# NextEra Energy Transmission West and Pacific Gas and Electric Company Estrella Substation and Paso Robles Reinforcement Project Proponent's Environmental Assessment (A.17-01-023)

## Response to Deficiency List No. 2

PEA Figure 2-6a. 230 kV Substation General Arrangement

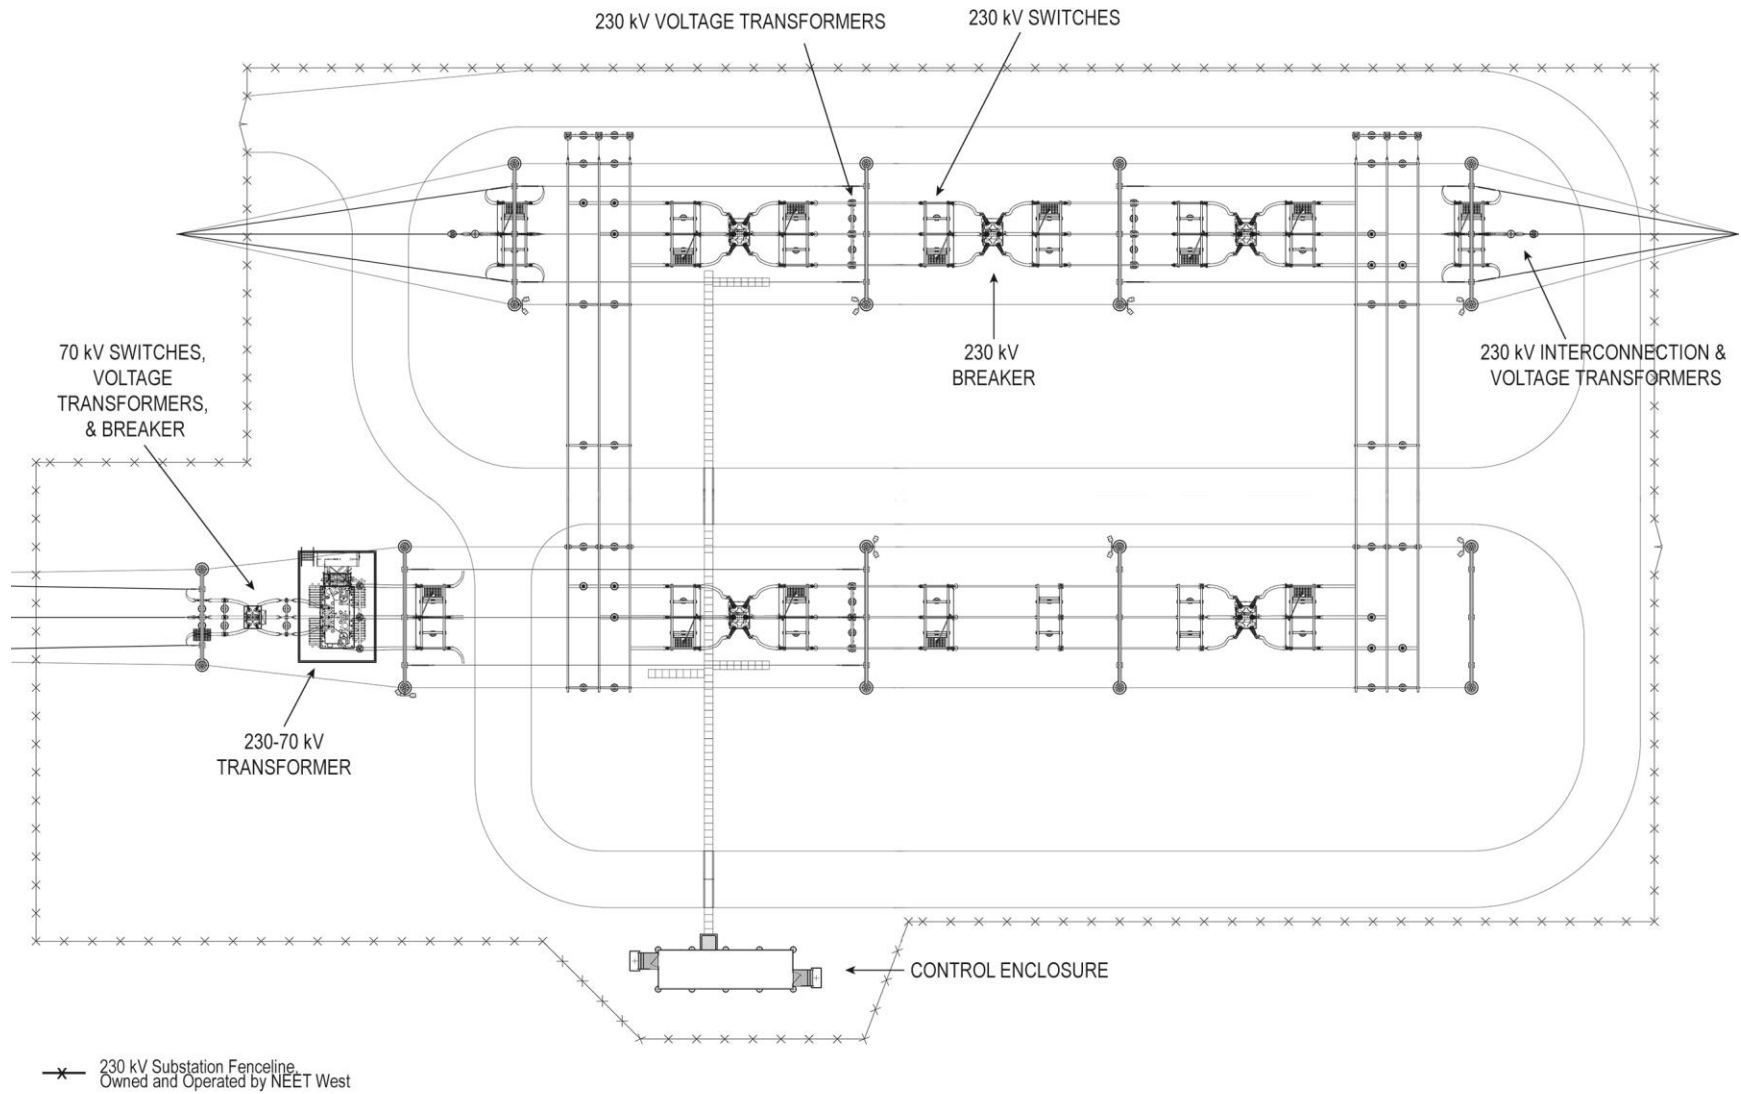
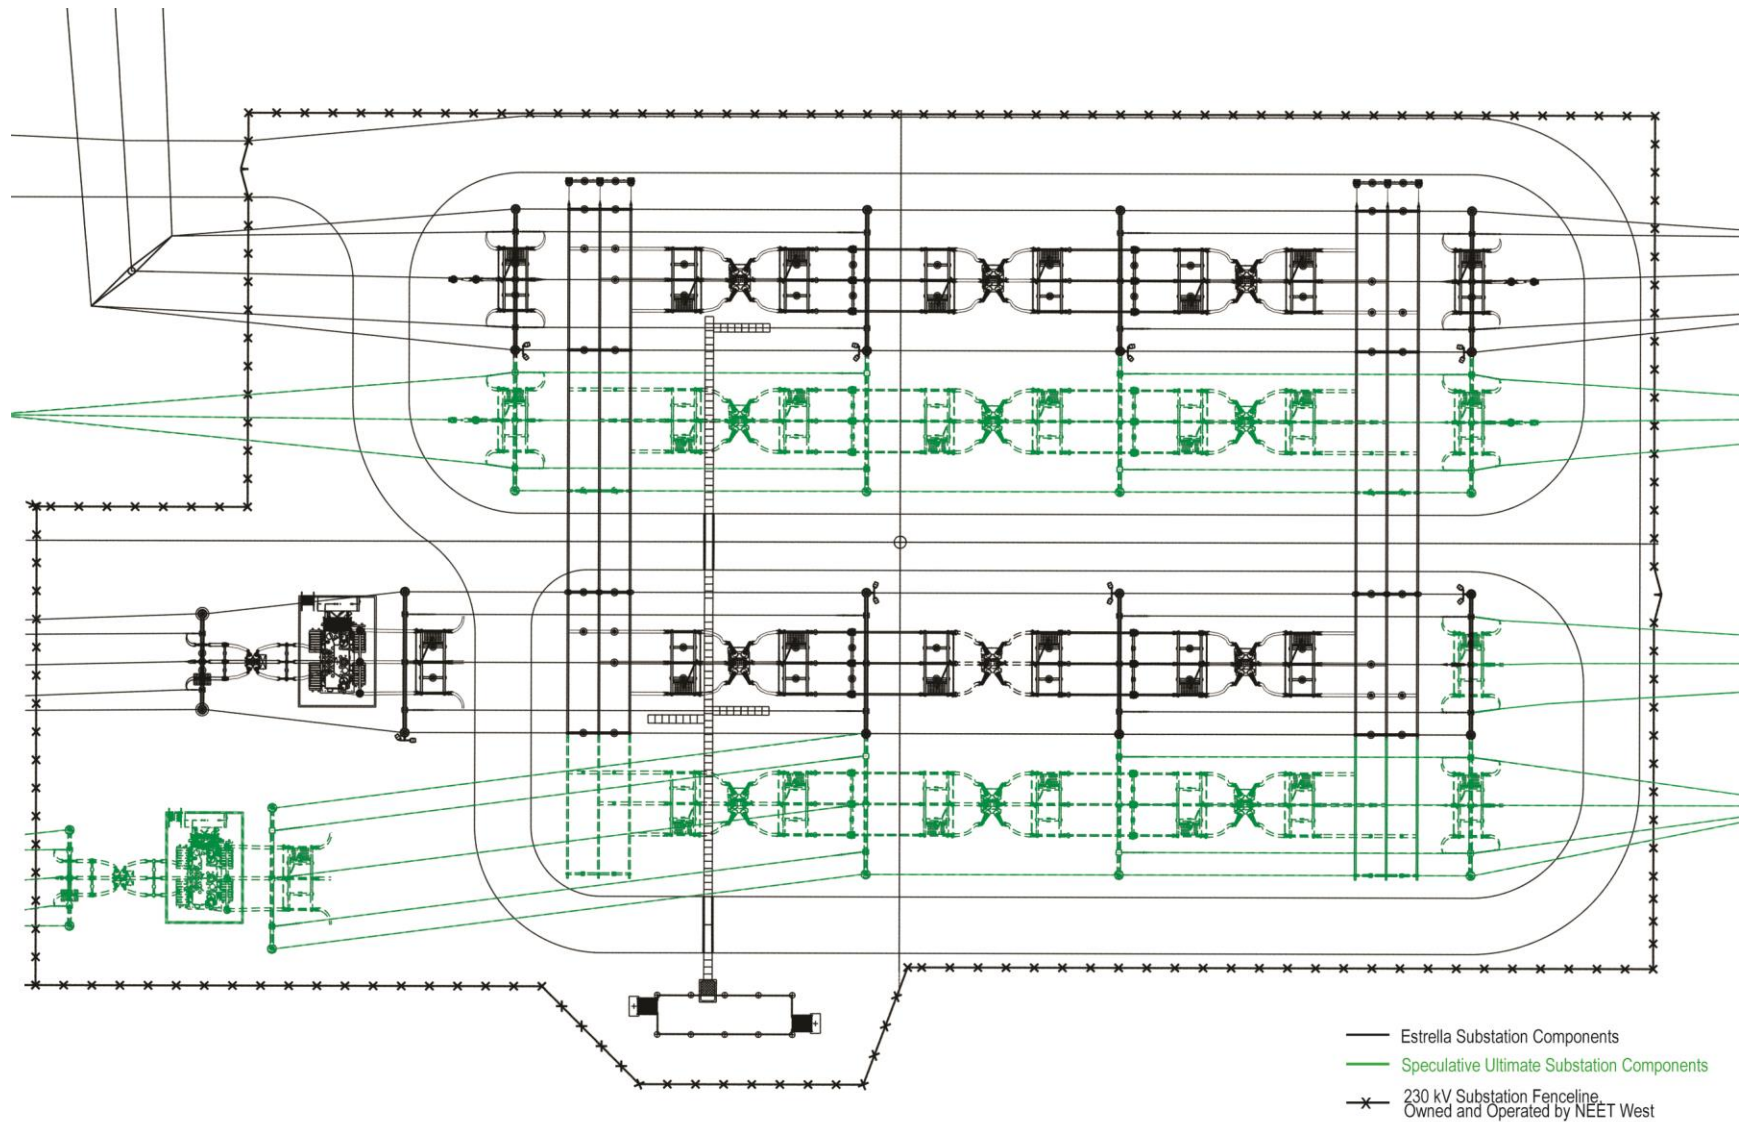
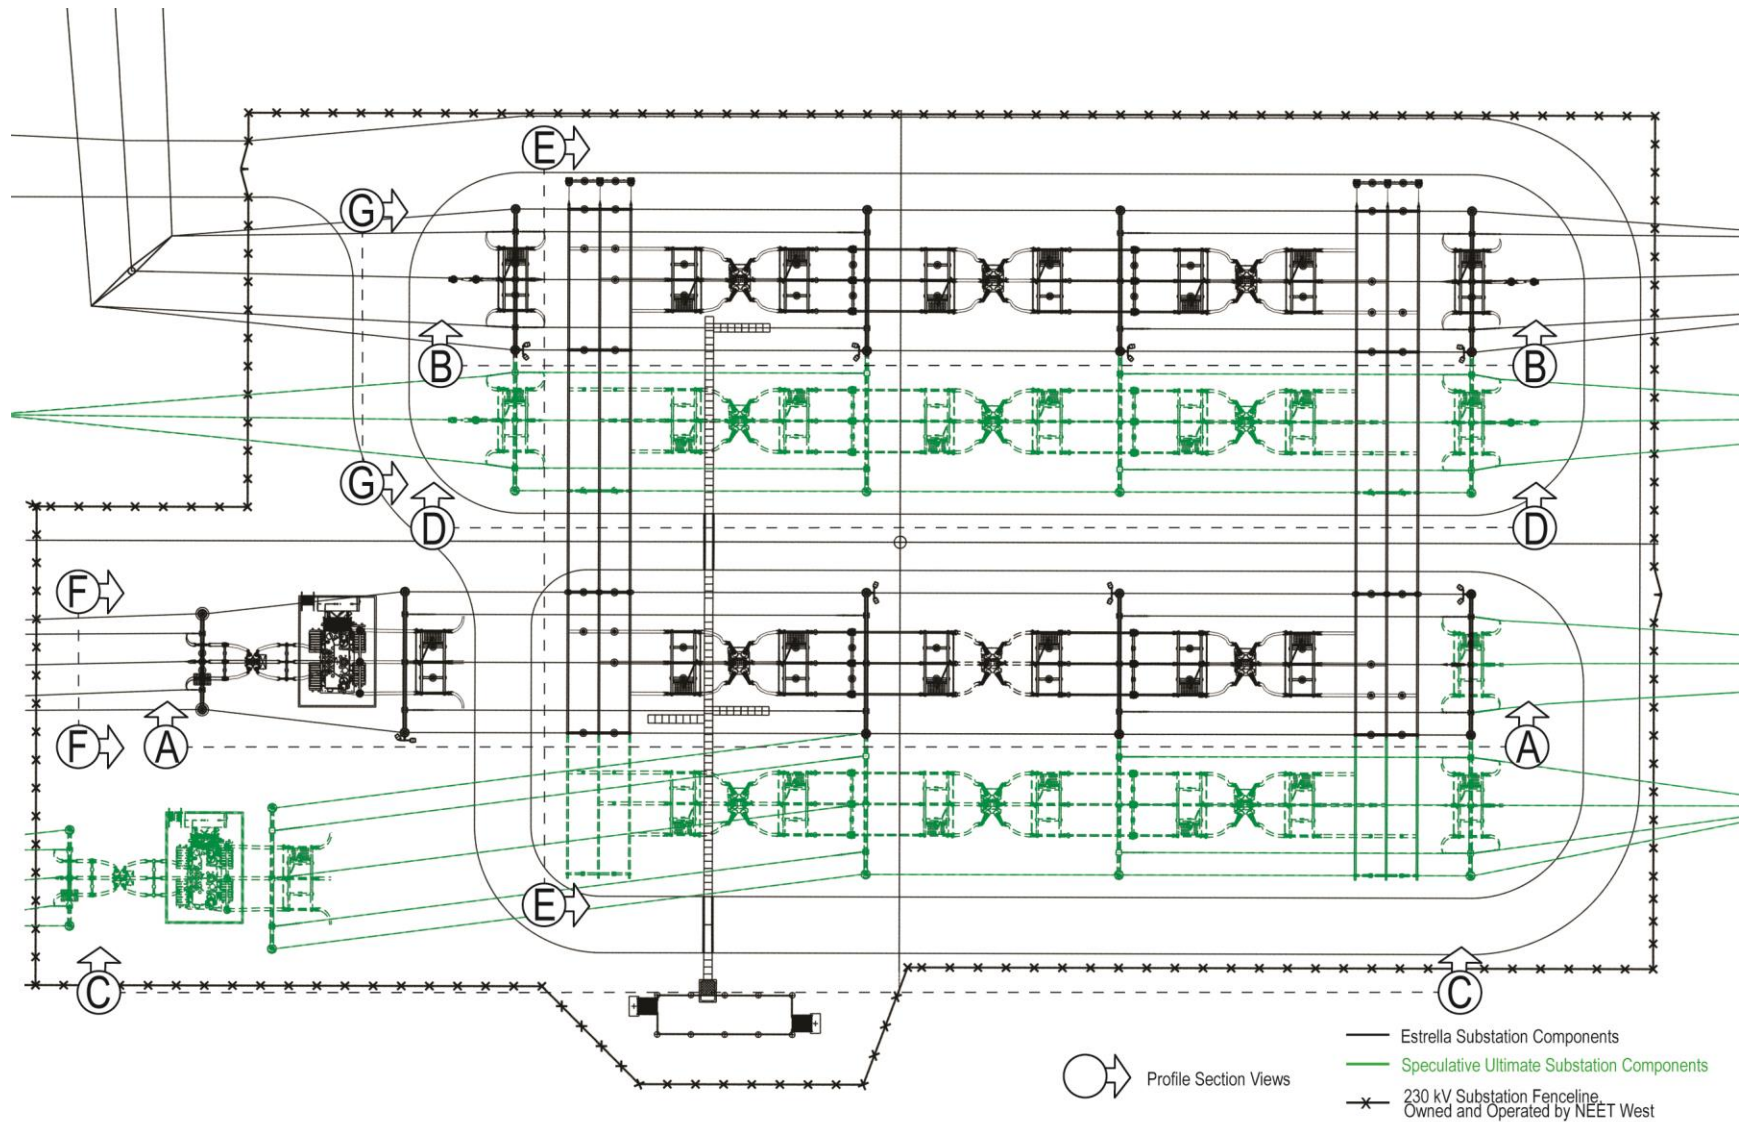
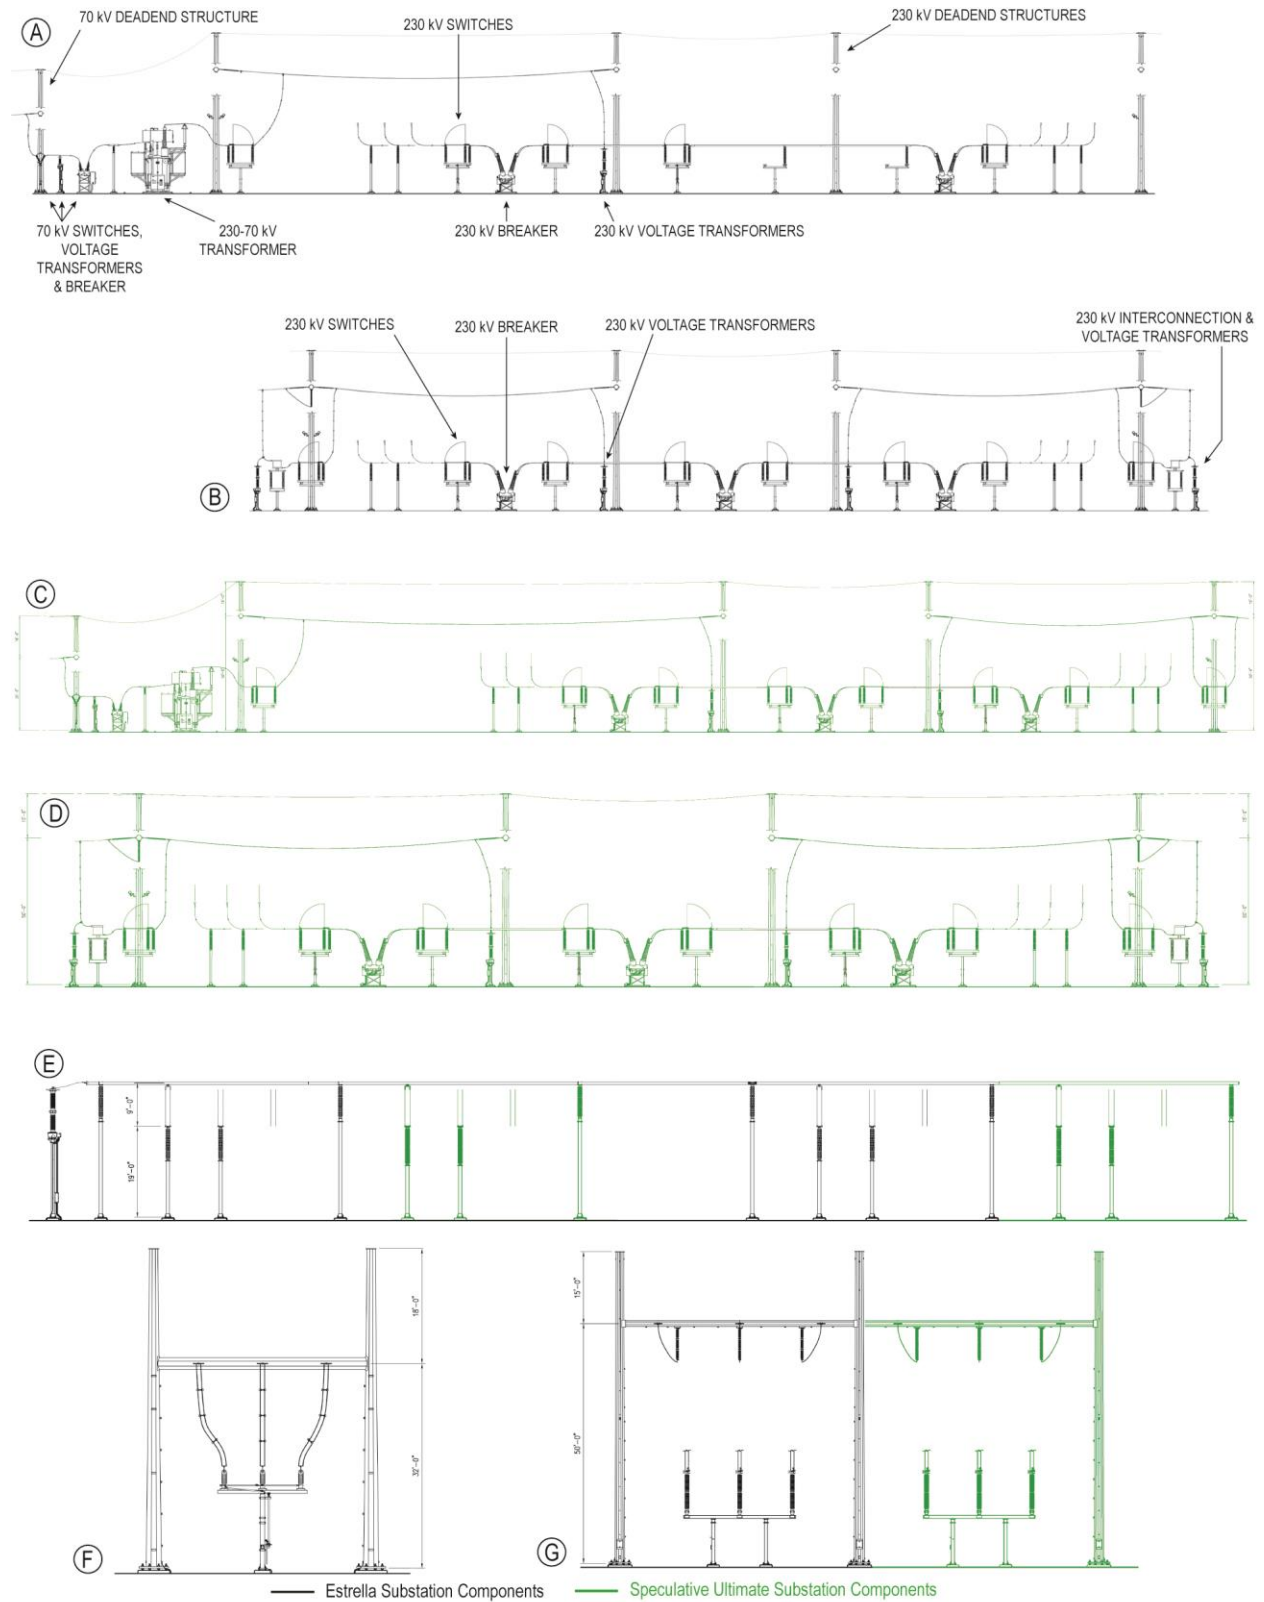
*Update Figures 2-6 and 2-7 with all future transmission facilities. Use a color or other means to indicate future/estimated build out.*

As described in the response to Deficiencies 20 and 21 on the PEA Deficiency List No. 1, the design of the ultimate substation build-out is not yet known, but space has been reserved at the substation to preserve the option of future expansion. Because ultimate substation build-out is not planned, designed, or reasonably foreseeable, its impacts are not analyzed in the PEA.

PEA Figures 2-6 and 2-7 have been updated to include a speculative view of an ultimate 230 kV Substation build-out including a future 230/70 kV transformer and associated breakers and switches, and a future 230 kV transmission interconnection (see Figures 2-6b and 2-7a and b). Current technology is assumed for purposes of the illustration.
